Access Compliance Report

Public Rights-of-Way

Intersection ID: 49347	Main Street: BLUE_JUNCTION_RD	Cross Street: BRYANT_FARMS_RD	Location: NW
ADA ID: 14F8ED948B35	Ramp Type: Perp	Initial Pass/Fail: Fail	Overall Compliance: No
		Severity Score: 8.75

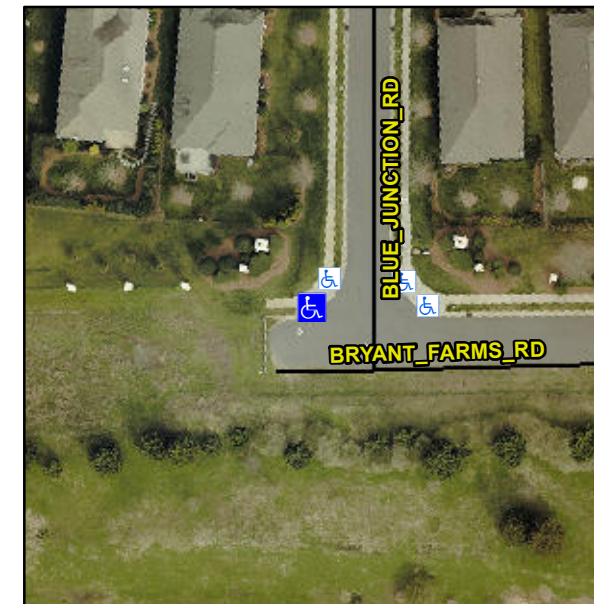
Not Found, R304.5.1

Compliance	Description	Data	Compliance	Description	Data
N/A	Ramp Length (in)	47.0	Yes	Ramp Slope (%)	7.0
No	Ramp Width (in)	47.0	Yes	Ramp XSlope (%)	1.3
N/A	Flare Type LT	N/A	N/A	Flare Type RT	N/A
N/A	Flare Slope LT (%)	N/A	N/A	Flare Slope RT (%)	N/A
N/A	Flare Traversable LT?	N/A	N/A	Flare Traversable RT?	N/A
N/A	Landing Length (in)	N/A	N/A	DWS Provided?	N/A
N/A	Landing Width (in)	N/A	N/A	DWS Contrast?	N/A
N/A	Landing Slope (%)	N/A	N/A	DWS Length (in)	N/A
N/A	Landing X Slope (%)	N/A	N/A	DWS Full Width?	N/A
N/A	Landing Curb? (Y/N)	N/A	N/A	DWS Offset (in)	N/A
N/A	Shared Landing?	N/A			
N/A	Gutter Ponding?	N/A	N/A	Gutter Slope (%)	N/A
N/A	Gutter Lip Ht (in)	N/A	N/A	Gutter X Slope (%)	N/A
N/A	Painted X Walk1?	No	N/A	Painted X Walk2?	N/A
	X Walk 1 Direction	To SW		X Walk 2 Direction	N/A
N/A	X Walk 1 Width (in)	N/A	N/A	X Walk 2 Width (in)	N/A
	X Walk 1 Slope (%)	4.3		X Walk 2 Slope (%)	N/A
	X Walk 1 X Slope (%)	0.8		X Walk 2 X Slope (%)	N/A

Remove & Replace Entire Ramp.
